building sign drawing

Revision 1 4/25/11

CITI TRENDS

Citi Trends Store
Great Souther Shopping Center
83 Great Southern Blvd
Columbus, OH 43207-4001

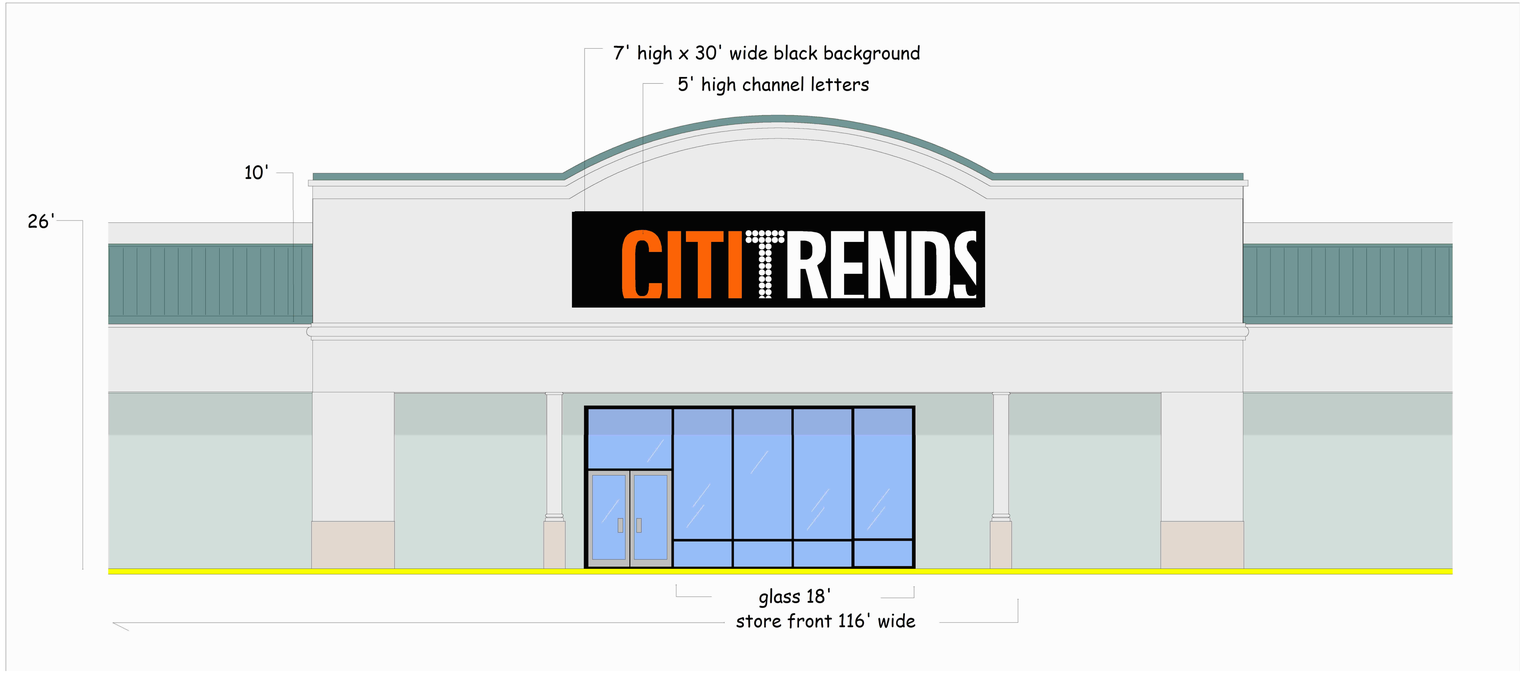
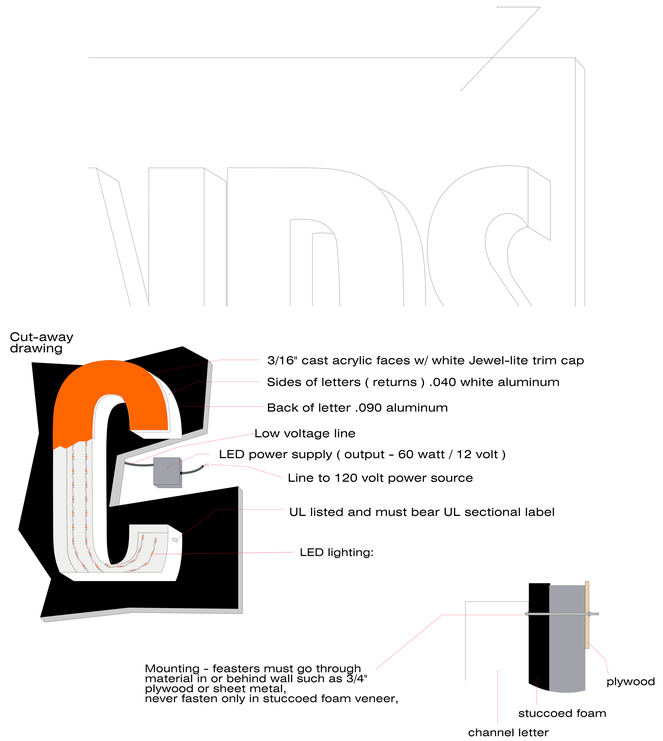
SIGN CODE - only allows 50 sq ft / this sign will require a variance.

A variance process is available, a variance usually is granted but it can take up to 4 months.
